UXR Responses to Comments - Noise

SUBJECT: WEST CAMPUS UPPER PLATEAU NOISE IMPACT ANALYSIS RESPONSE TO COMMENTS

Exhibit A: Cumulative Project Locations

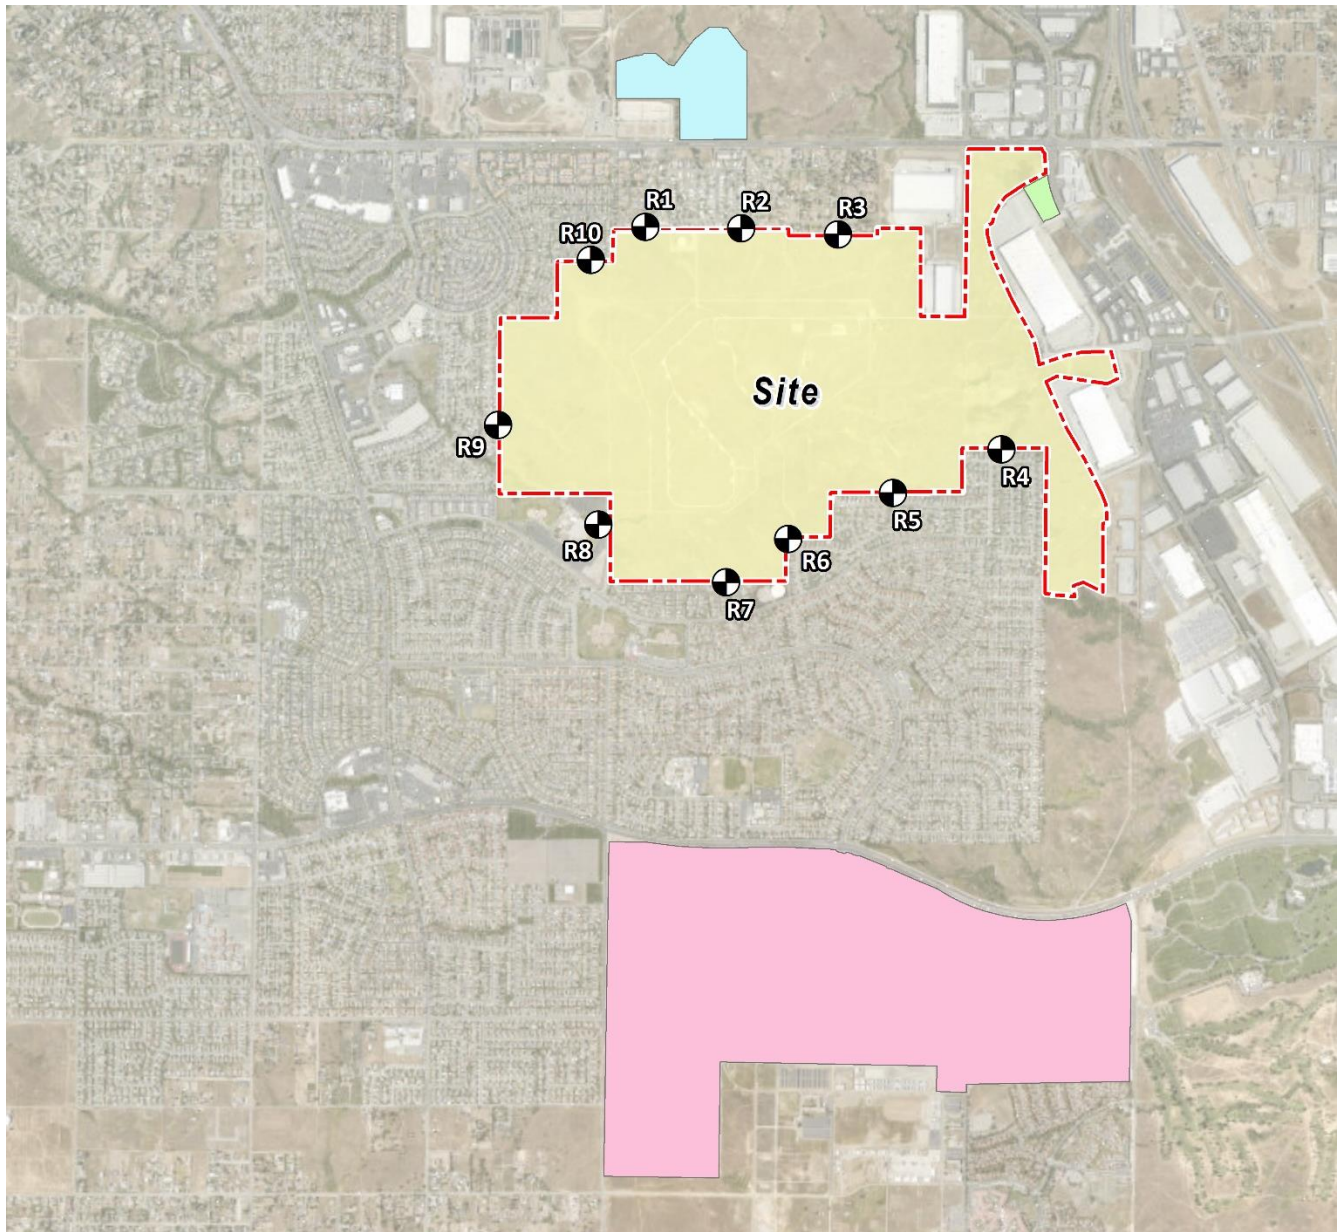
The commenter requests cumulative construction analysis of other “under construction projects” including Sycamore Hills Distribution Center, Meridian South Campus Buildings F, G, and 1, and Meridian West Building 4 as shown below on Exhibit A. Since noise levels diminish quickly at a rate of 6 dB for each doubling of distance from a source, the potential cumulative construction noise source activities are expected to be lower than the Project related construction noise levels. This is largely due to distance, topography, intervening building structures and development between the nearest noise sensitive receiver locations and the potential “under construction projects”. Using the same reference construction equipment noise levels published by the Federal Highway Administration (FHWA) in the Roadway Construction Noise Model (RCNM), in combination with the same FTA guidance for noise assessment used in the Project Noise and Vibration Analysis, we calculated the potential construction noise levels for each of the “under construction projects.” The construction noise levels from the Sycamore Hills Distribution Center are expected to range from 32.5 to 46.2 dBA Leq at the Project noise sensitive receiver locations without accounting for any intervening building structures or topography. The cumulative construction noise levels from the Meridian South Campus are estimated at 24.8 to 34.8 dBA Leq, and 30.2 to 42.5 dBA Leq from Meridian West Building 4. With the Project related construction noise levels ranging from 33.7 to 48.0 dBA Leq, the cumulative construction noise levels are not expected to meaningfully contribute to a potential cumulative construction noise increase

In addition, the existing ambient noise levels ranging from 47.3 to 61.5 dBA Leq show that noise from intervening roadways, specifically Alessandro Boulevard for the Sycamore Hills Distribution Center and Van Buren Boulevard for the Meridian South Campus development, will likely overshadow the potential cumulative construction noise source levels from these external projects.

Therefore, the proximity of the West Campus Upper Plateau project site to the nearest noise sensitive receiver locations suggests that any potential cumulative construction noise levels will be diminished below ambient levels and washed out by intervening roadway traffic noise.
